## Department of Planning and Zoning

**TO:** Development Review Board  
**FROM:** Scott Gustin  
**DATE:** April 16, 2013  
**RE:** 09-396CA/MA; 163 South Willard Street

**Request:** Amendment to ZP#09-396CA/MA to modify approved parking plan by adding parking spaces.

### LOT COVERAGE PLAN

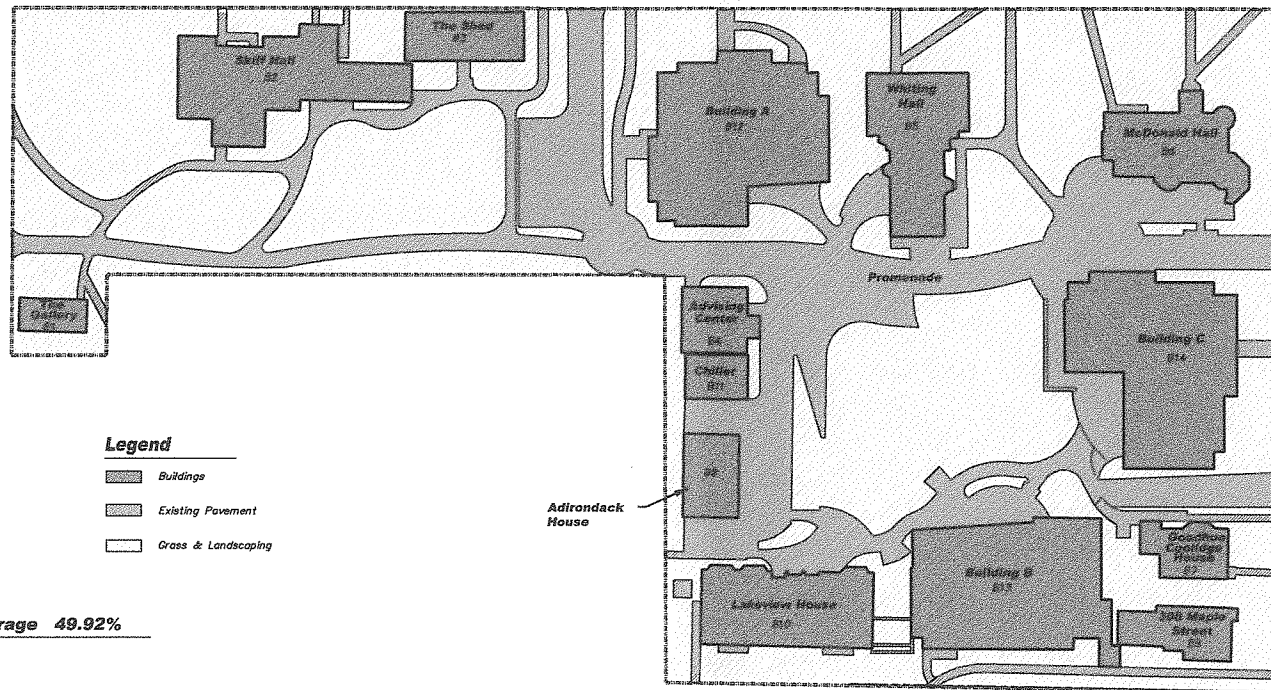
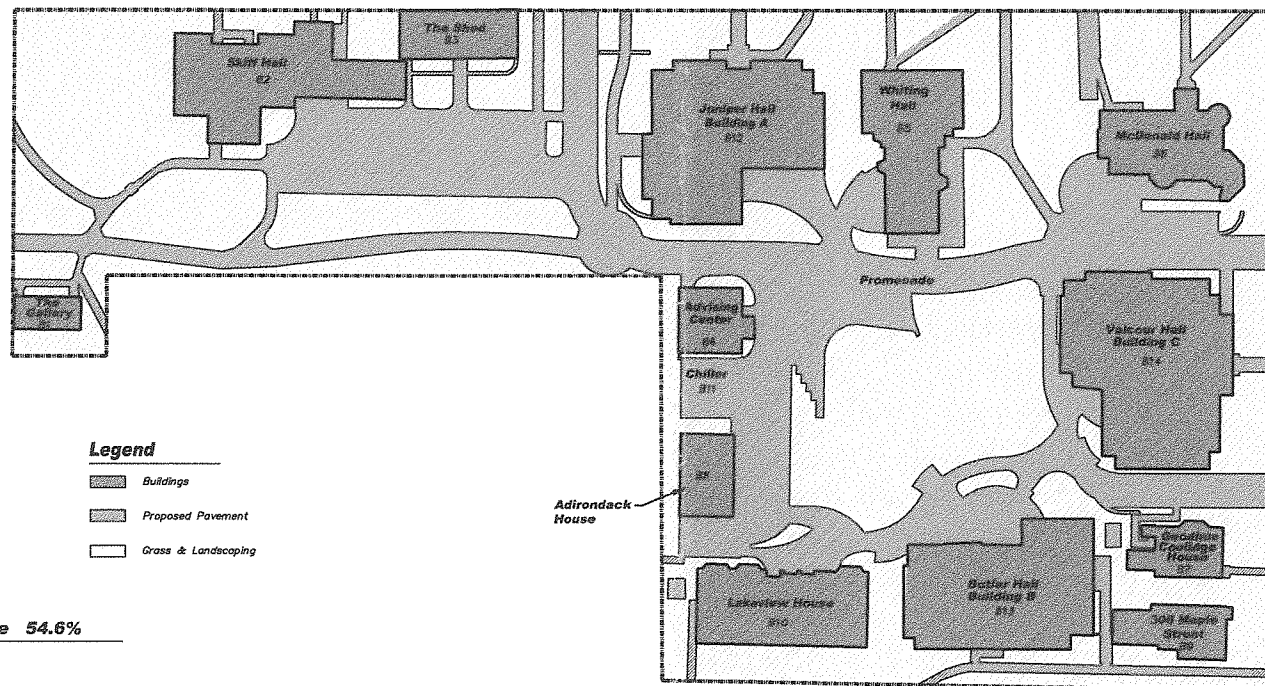
Within this overlay district, a maximum aggregate lot coverage of 60% is allowed. This amendment will increase the approved lot coverage from 49.9% to 54.6%. **(Affirmative finding)**

**SITE PLAN C**

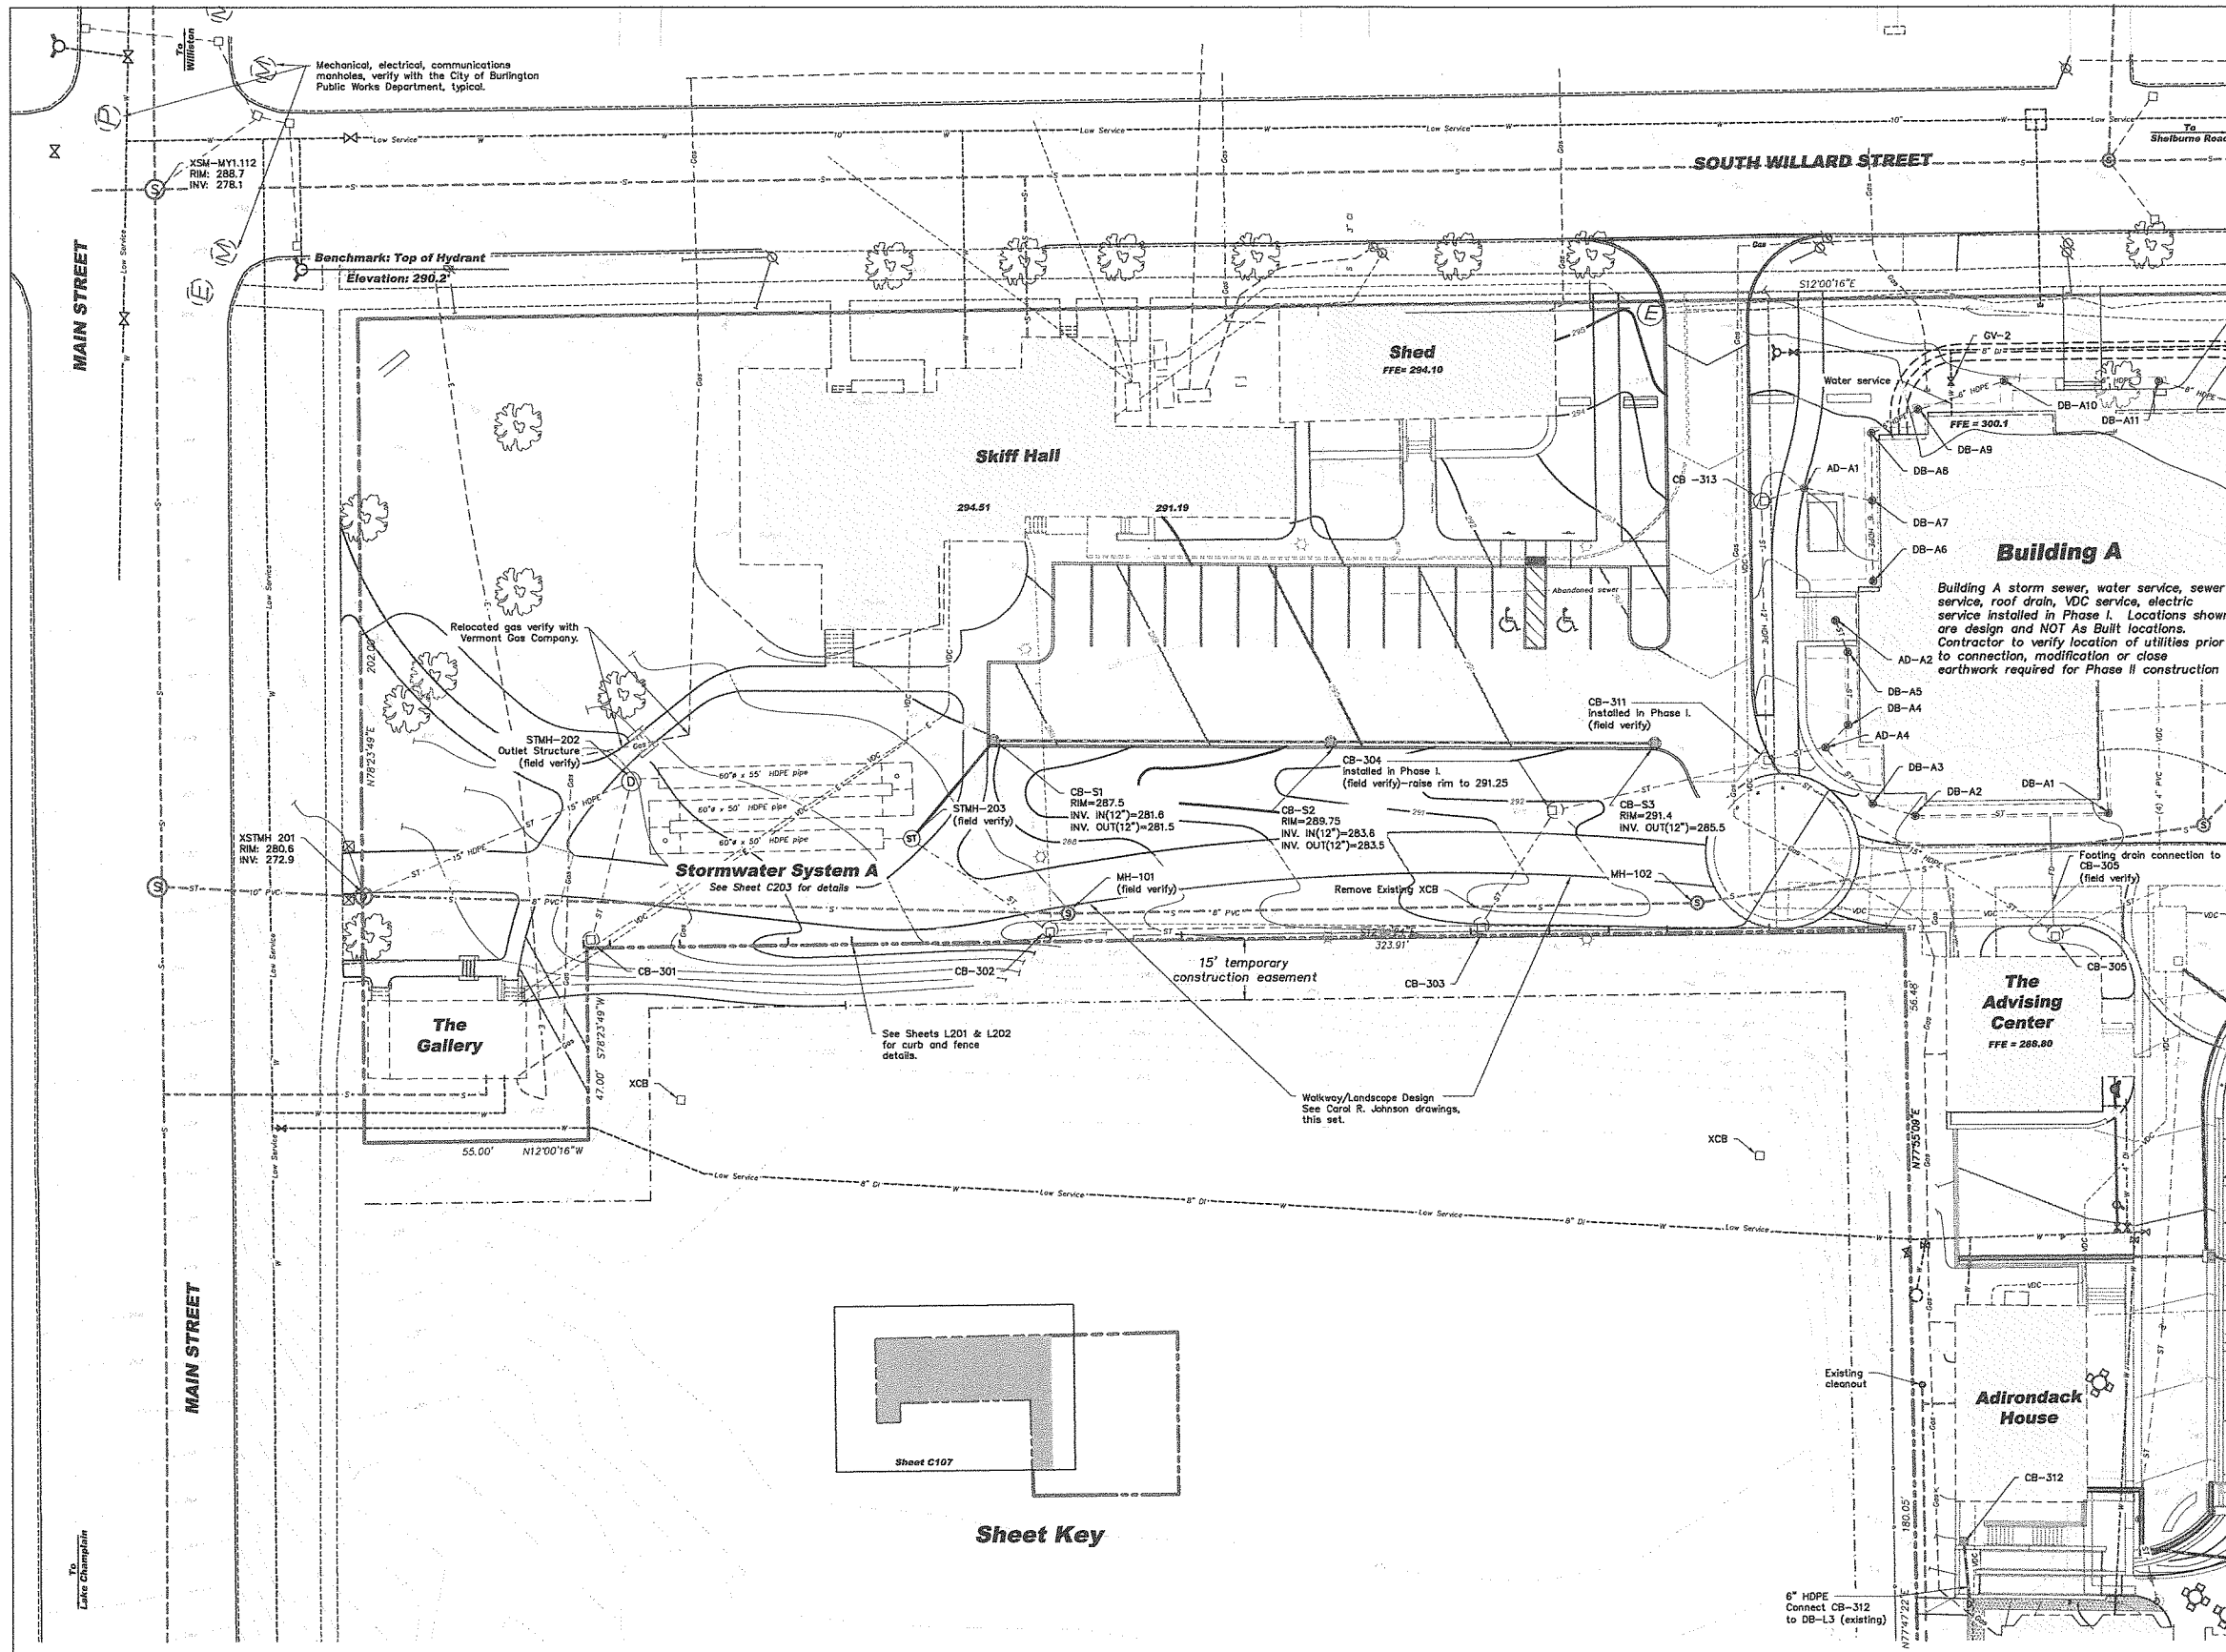
The parking area will be illuminated by pole-mounted light fixtures as originally approved. A photometric plan depicting illumination levels of the revised configuration has not been provided. Such a plan needs to be provided in order to confirm compliance with applicable lighting standards. **(Affirmative finding as conditioned)**

Except for a slight change to install additional piping and catch basins in the amended parking area, no changes to the stormwater management system are proposed. No changes to the erosion control plans are proposed. **(Affirmative finding)**

1. **Prior to release of the zoning permit**, a photometric plan for the amended parking area shall be submitted subject to staff review and approval.
2. The amended parking area shall be incorporated into the 2014 update of the 2009-2014 Joint Institutional Parking Management Plan.
3. Standard permit conditions 1 -15.
